**UNITED STATES OF AMERICA
BEFORE THE
FEDERAL ENERGY REGULATORY COMMISSION**

Standardization of Generator Interconnection Agreements and Procedures) **Docket No. RM02-1-000**
)

**COMMENTS OF THE NORTH AMERICAN ELECTRIC RELIABILITY COUNCIL
REQUESTING CLARIFICATION OF PROPOSED RELIABILITY REQUIREMENTS**

Figure 1 – Clock Hour Integrated Energy Inadequate to Measure Schedule Following
Reliability Issue 4: Forced Outage Notifications

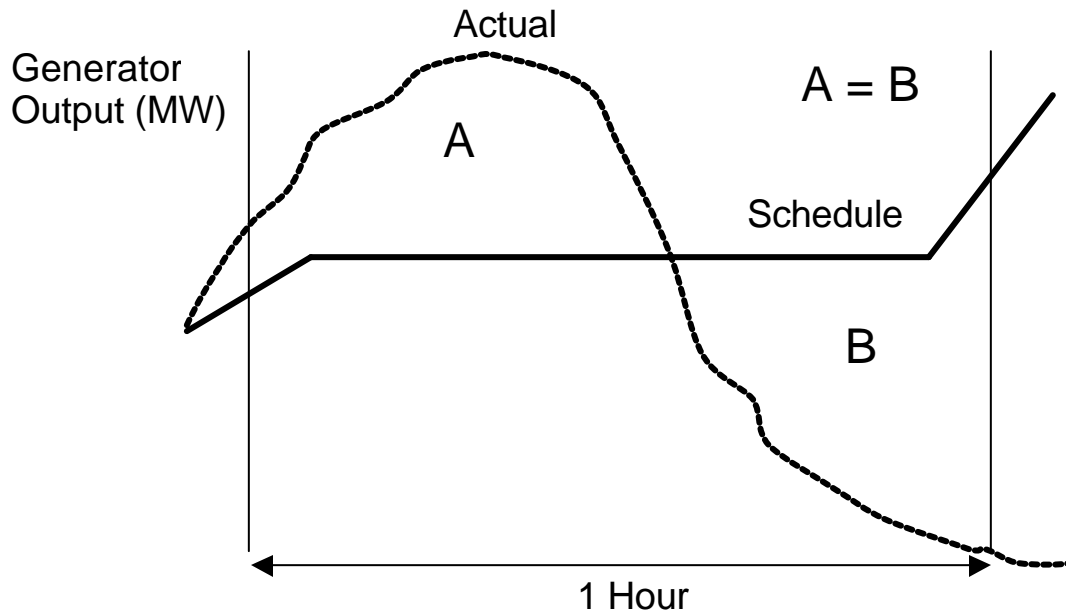
The IA infers that the Generator's balancing obligation is to match output with its scheduled delivery on an integrated clock hour basis. Integration of the delivered energy over an hour is a measure of delivered energy used for settlement purposes and is insufficient to describe the Generator's obligation to match its actual output with scheduled delivery continuously within a scheduling period. Furthermore, a scheduling period could be some duration other than a clock hour.

As shown in the conceptual diagram in Figure 1, a Generator can match its actual output over an hour with its integrated clock hour scheduled delivery, yet substantially over-generate for part of the hour and under-generate for part of the hour. If such intra-hour imbalances become accepted practice, they could cause performance control problems such as frequency excursions, unscheduled power flows on the bulk electric system, and conditions that are unsafe or that have not been studied.

IA Article 4.3.1. Generator Balancing Service Arrangements:
Generator is responsible for ensuring consistent the scheduling requirements of the Transmission Provider's FERC-approved tariff and any applicable FERC-approved market structure, that its actual Facility output matches the scheduled delivery from the Facility, ~~on an integrated~~ ~~clock-hour basis,~~ to the Transmission Provider's Transmission System, including ramping into and out of such scheduled delivery, as measured at
